AVO Carbon INDIA	8D REPORT	Fromat no:F/QAD/8D/09 Rev no:00 Rev date:16.08.2022

Title: 46770009 Brush Thickness oversize found customer assy line **Supplier:** AVO Carbon india Pvt ltd

Part No: 16770009(46770009) Avo Part # 9227-01 **Place:** Chennai-98

Present Process

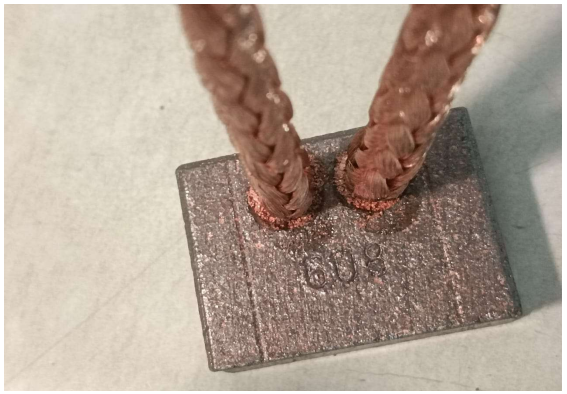
Presently followed the above process for flex insertion we done drilling and tamping, it create little burr projection leads to thickness higher side

The above proposed process, flex insertion can be done with pilling operation itself, so we prevent the burr projection on tamping process
